**Section 16 Application for Partial Conversion of an Existing Commercial Building for Proposed 'Hotel (Student Hostel)' Use at 86 Hung To Road, Kwun Tong, Kowloon**

**Planning Application No. A/K14/838**

**Further Information 2**

**Responses-to-Comments**

**Figure 2.3: Air Intake Location and Sensitive Use within the Project Building**

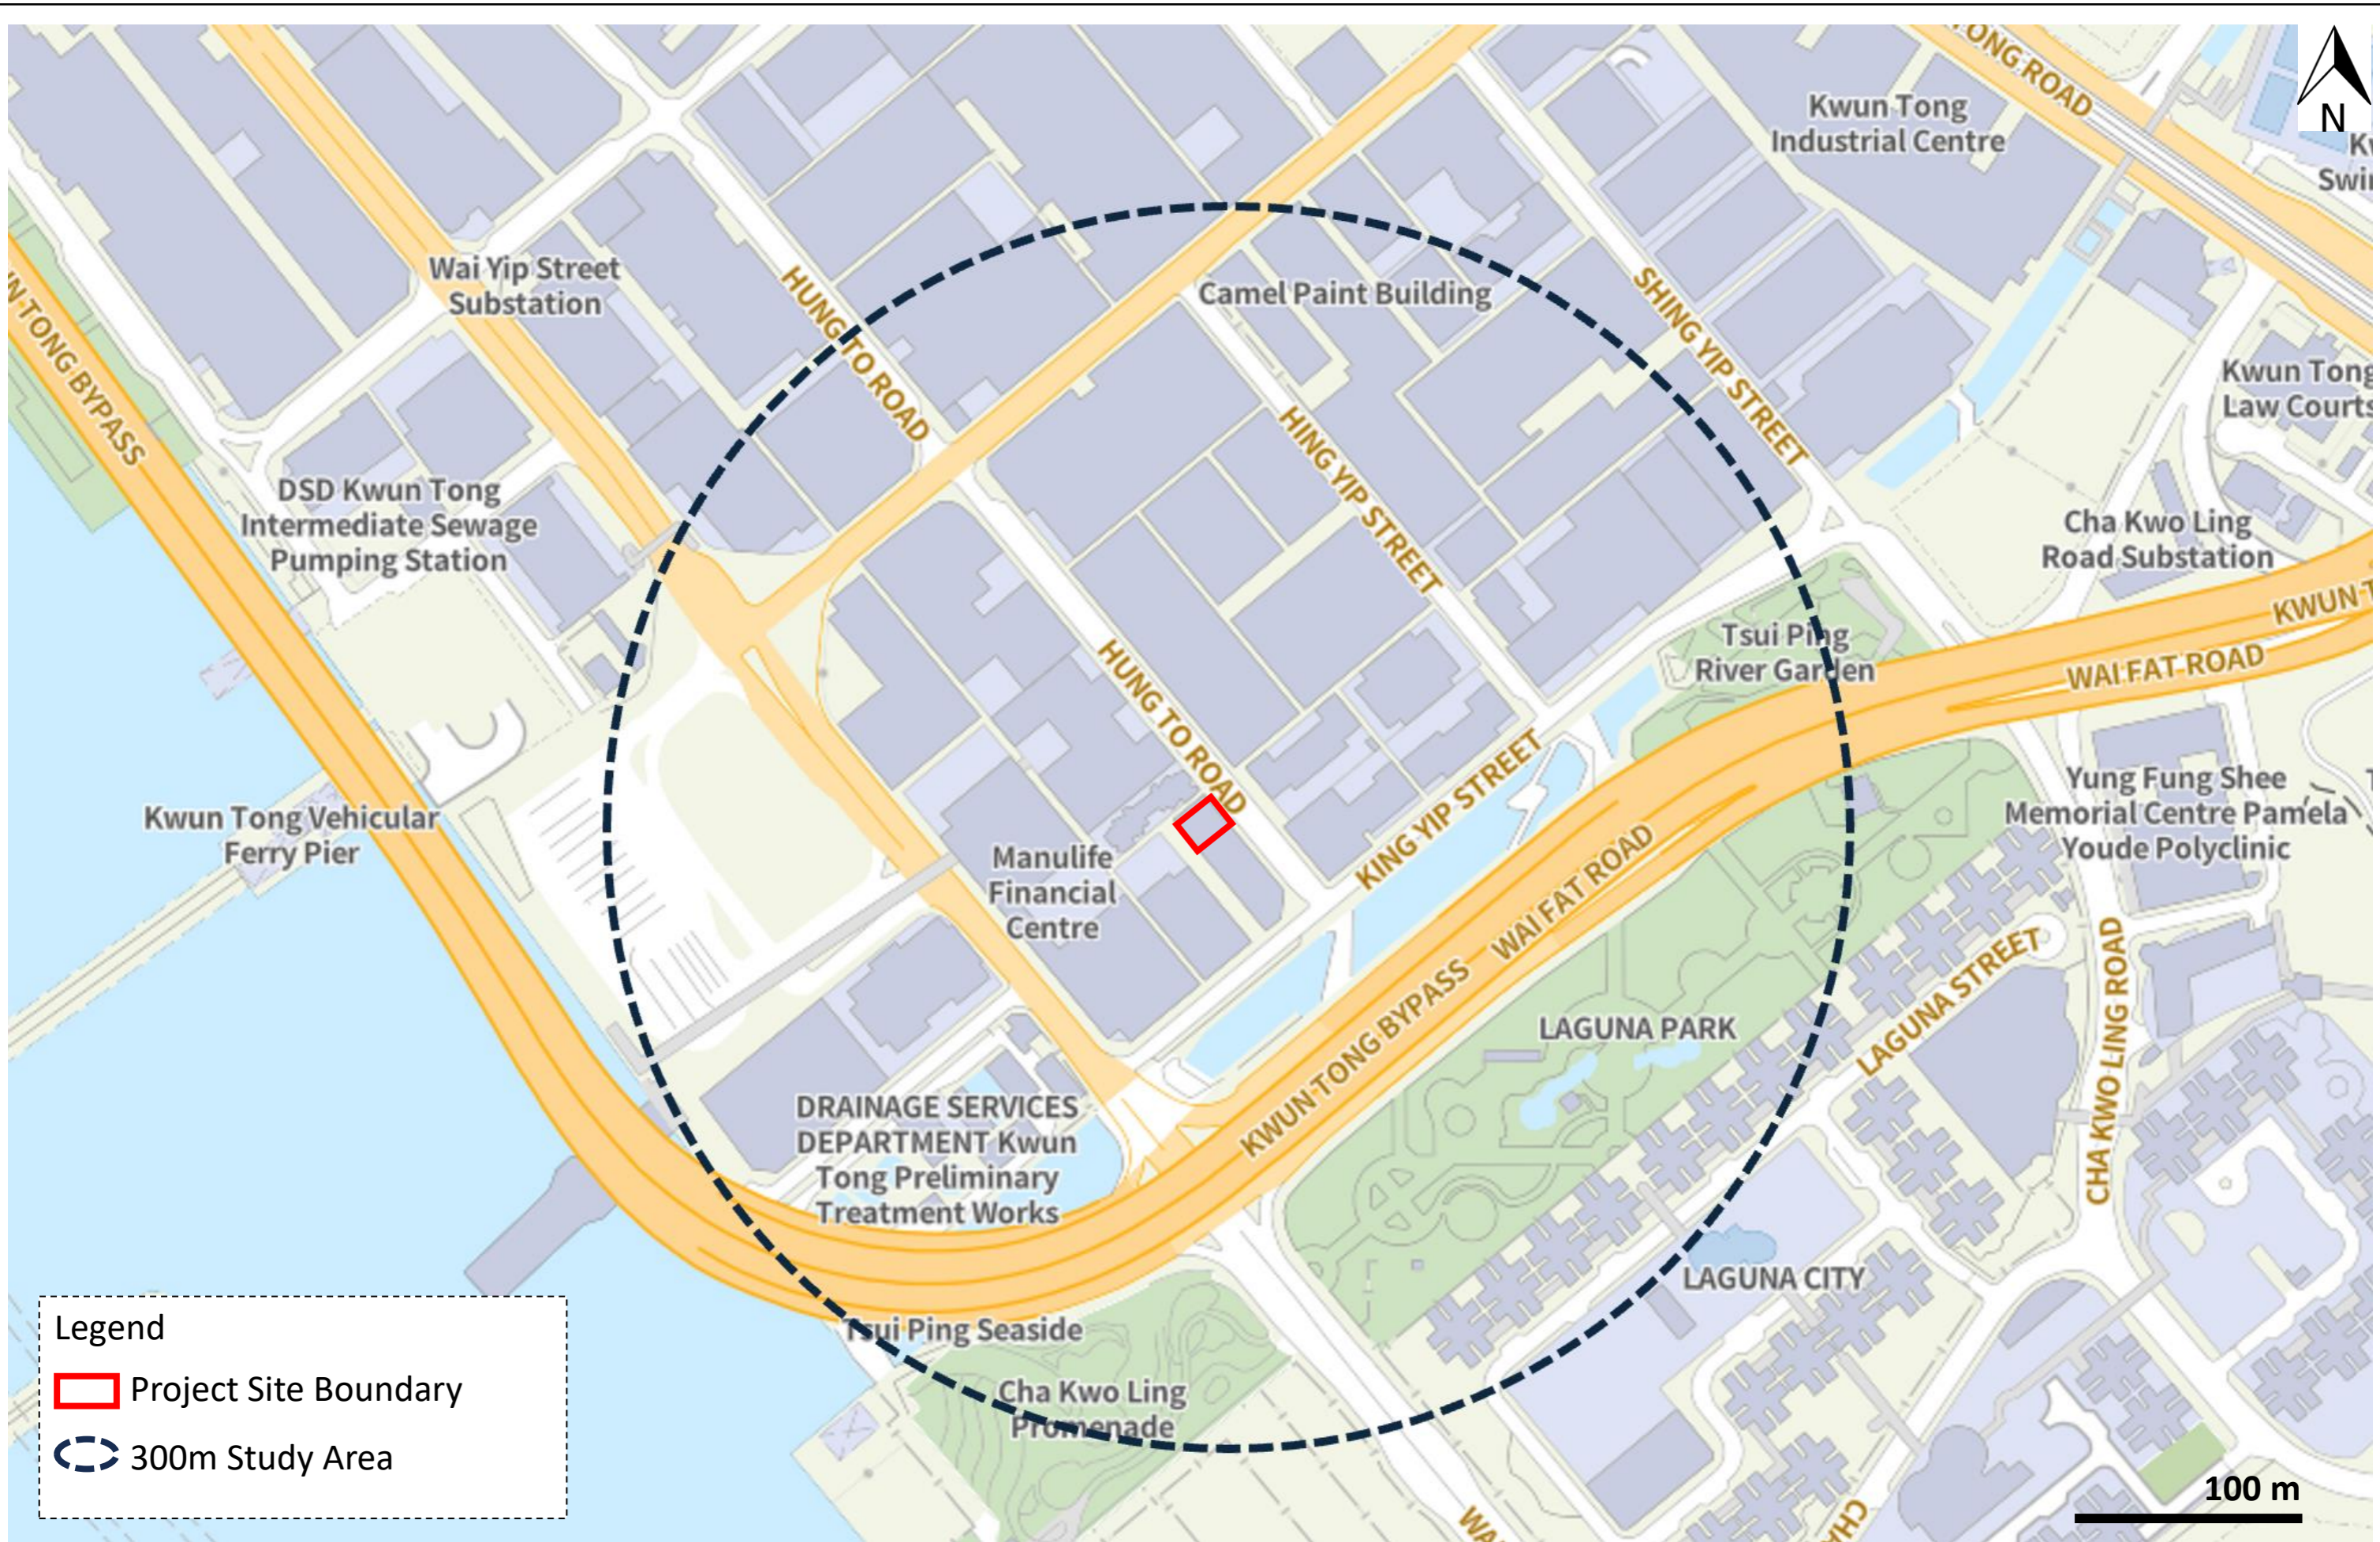
9.	<p>Section 2.4.4, Table 2.5, Figure 2.3 &amp; R-t-C#8:</p> <p>(a) In Table 2.5, please amend the distance between the project building and Hung To Road, which should not be 7m as per Section 2.4.4.</p> <p>(b) Figure 2.3: Please mark the 5m buffer distance from Hung To Road to demonstrate compliance with the 5m buffer distance requirement. Please also compare the 5m buffer distance of Hung To Road against the layouts of all floors to determine which windows should be sealed. Please quote Figure 2.3 in Section 2.4.4.</p>	<p>Noted. <b>Table 2.5</b> has been updated accordingly.</p> <p>Noted. The 5m buffer zone and sealed windows positions have been marked on <b>Figure 2.3</b>.</p>
